# UNITED STATES PATENT AND TRADEMARK OFFICE

APPLICATION NO.	FILING DATE	FIRST NAMED INVENTOR	ATTORNEY DOCKET NO.	CONFIRMATION NO.
09/828,358	04/09/2001	Karel van den Berg	8553/213	1711

**Office Action Summary**

## **DETAILED ACTION**

*Fig. 3.*  
(Modified)

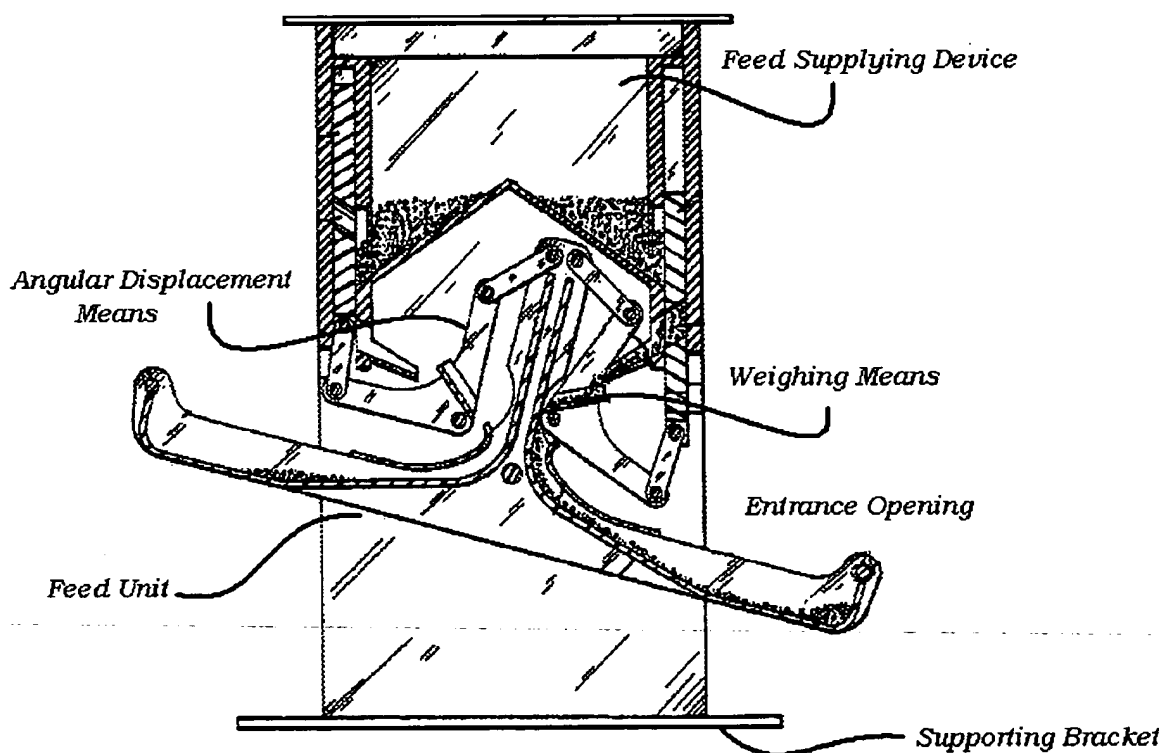
9. Claims 1, 31 and 41 are rejected under 35 U.S.C. 102(b) as being anticipated by Anderson, US Patent 5,255,631.

Anderson discloses a feed metering device for providing feed in measured portions to an animal comprising a feed unit, entrance opening, feed supplying device, weighing means wherein said feed unit is connected to the feed supplying device by an angular displacement means which comprises said weighing means, further comprising a supporting bracket for the feed unit.
